Updated Compressor Design: 6511696

TECH TIP

#203

gpd now offers an updated compressor design for 6511696 for:

6511696 DESIGN UPDATES:

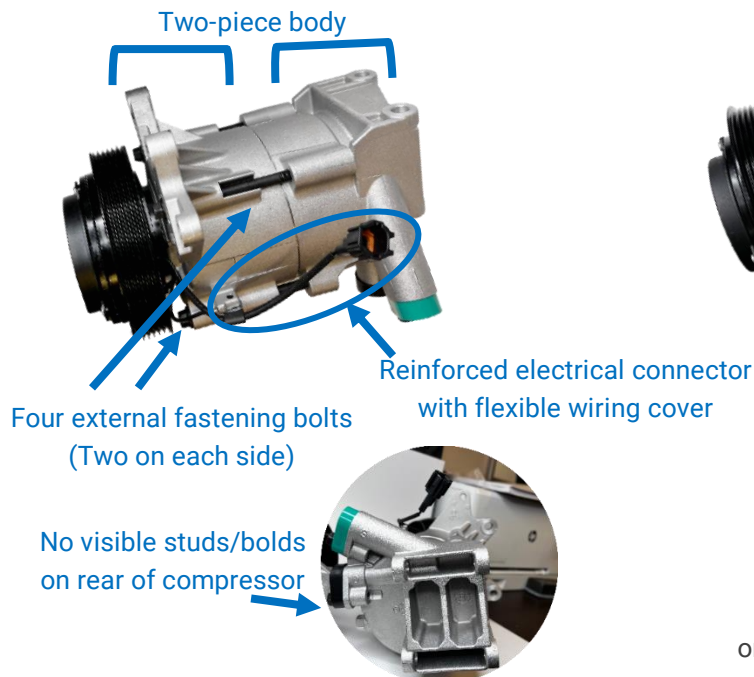
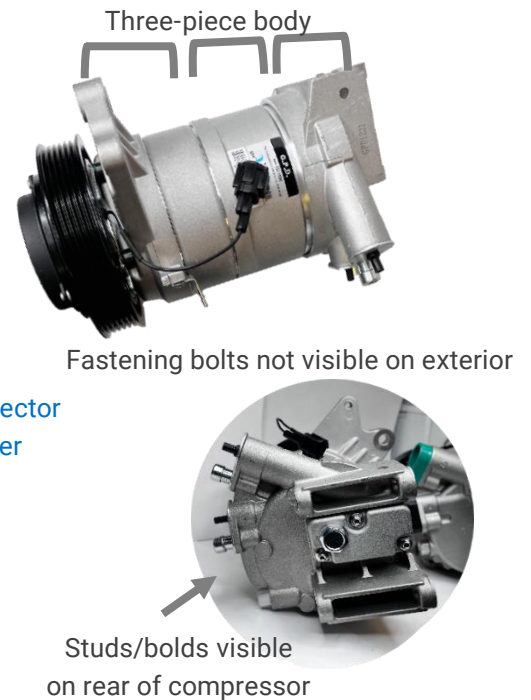
- Reinforced electrical connector with flexible wiring cover
- Two-piece body design vs. previous three-piece body design
- Four exterior body bolts vs. previous body design with five interior bolts
- Rear redesigned to protect rear studs/bolts

Redesigned as a two-piece body with four external fastening bolts.

External appearance matches OE design.
